INTERNATIONAL STANDARD

Specification for radio disturbance and immunity measuring apparatus and methods –

Part 1-3: Radio disturbance and immunity measuring apparatus – Ancillary equipment – Disturbance power

Figure 3 – Schematic overview of the clamp calibration methods

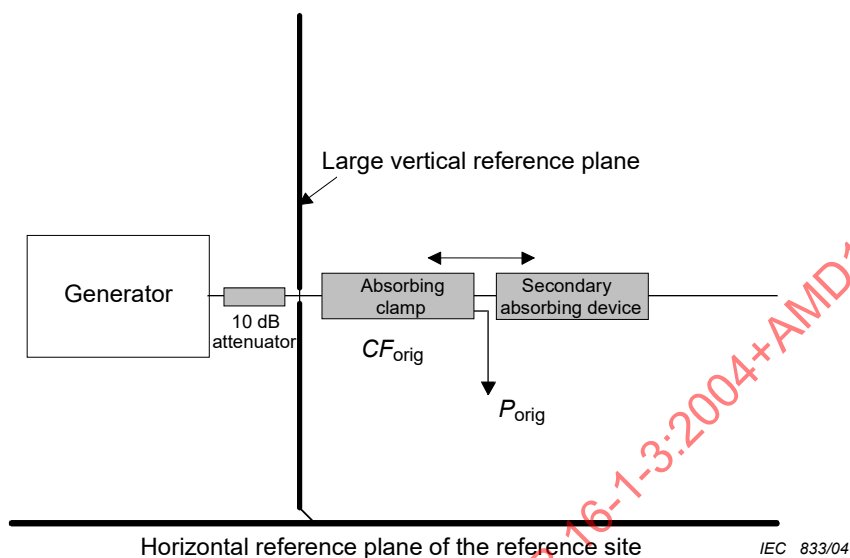
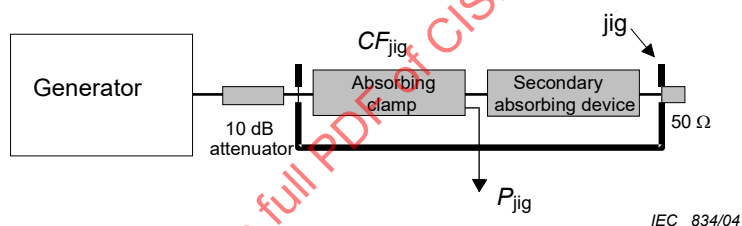
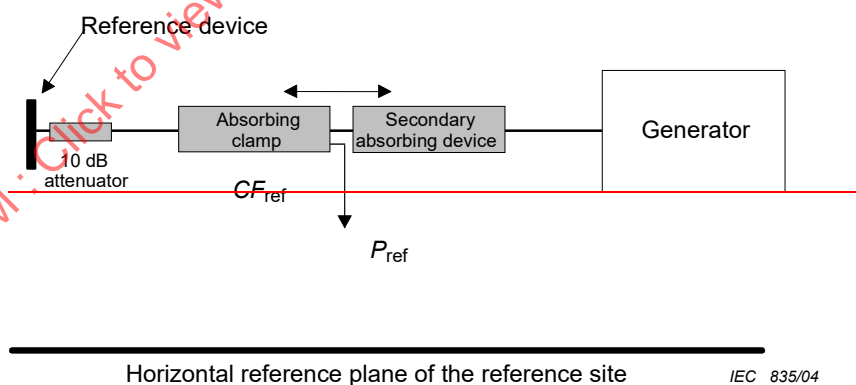
~~Three~~ Two absorbing clamp calibration methods are developed below, each with their own advantages, disadvantages and applications (see Table 1). Figure 3 gives a schematic overview of the ~~three~~ two possible methods.

~~The reference device method uses a reference site (without vertical reference plane) and a reference device that is fed through the lead under test, which is a coaxial structure for this purpose (see Figure 3d).~~

Figure B.6 – Test set-up for the reference device calibration method

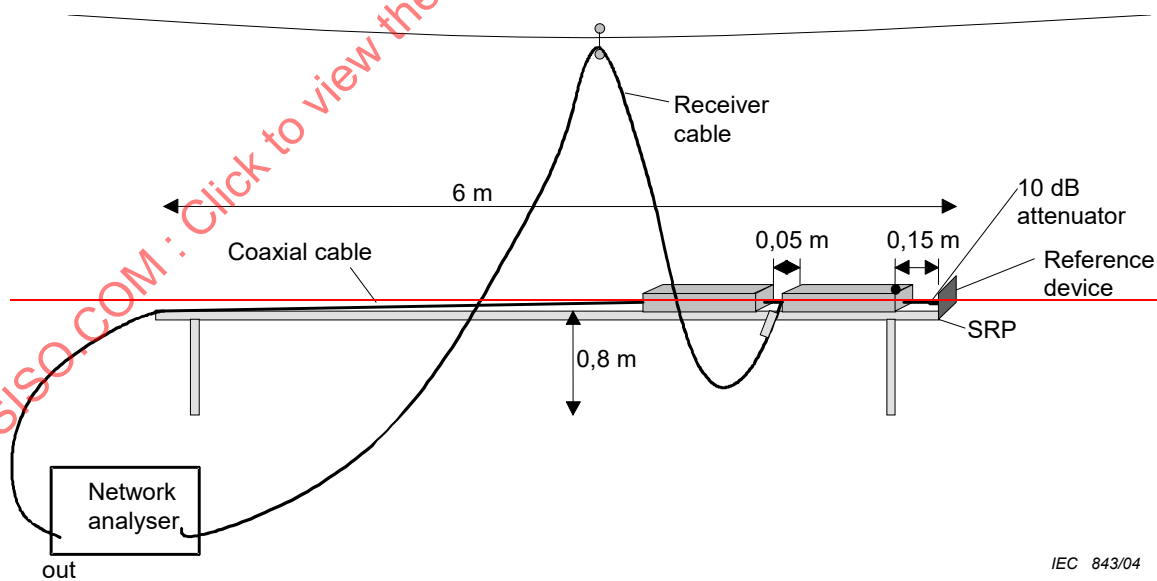
~~The reference device replaces the large vertical ground plane in the original calibration procedure on an ACRS. The calibration set-up is shown in Figure B.6. The site suitable for this calibration method is the ACRS. An ACRS that is valid for this calibration procedure is an OATS or a SAR for a 10 m measurement distance that complies with the CISPR NSA requirements.~~

Figure B.7 — Specification of the reference device

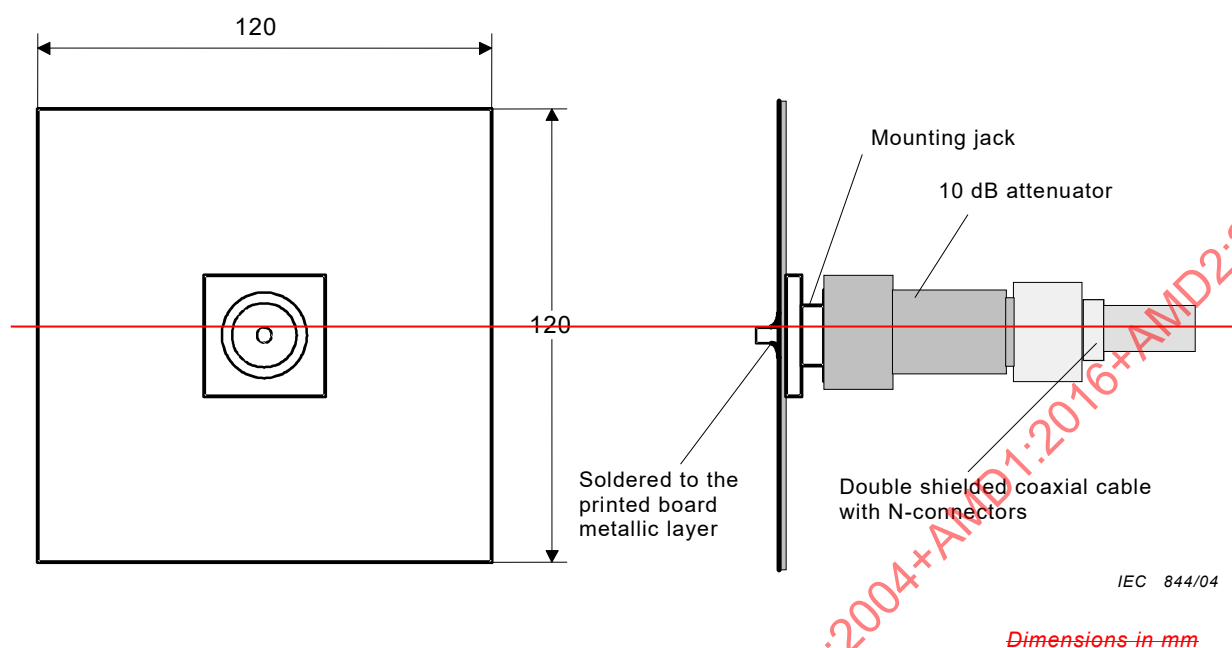
Both clamps — the clamp under test and the second (ferrite) clamp (SAD) — are positioned on the clamp slide as shown in Figure B.7. The current transformer of the clamp under test is placed with its side towards the reference device, which is positioned at the SRP of the clamp slide. The front edge of the current transformer is the clamp reference point (CRP) and shall be marked on the clamp case by the manufacturer. The clamp is positioned with a distance of 150 mm between the CRP and the reference device. The lead under test (the coaxial cable from the network analyzer) is passed through both clamps and should be stretched slightly using an appropriate non-metallic clamping device at both ends of the clamp slide.
